The duration of yellow light change interval at Cary Town Blvd and Convention is less than the minimum required by law.

| SR 1497 (WESTERN BOULEVARD EXT.) AND CONVENTION DRIVE - PRINCIPAL LANE | | |

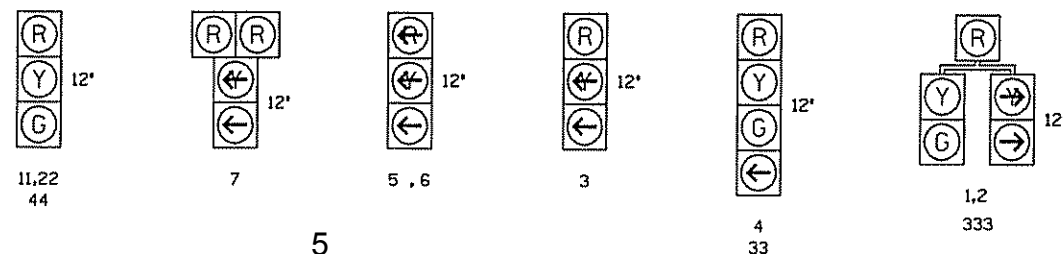
Calculate the minimum yellow light duration at the intersection of Cary Town Blvd and Convention (the Mall Entrance). The speed limit signs say 45 mph.

The current duration is 4.0s according to the signal plan.

In all cases, the current duration is shorter than the NCDOT Design Manual requires.

$$= 4.5\text{s} \text{ (rounded up to nearest .1 s as directed by STD 5.2.2, Sheet 4 of 4)}$$
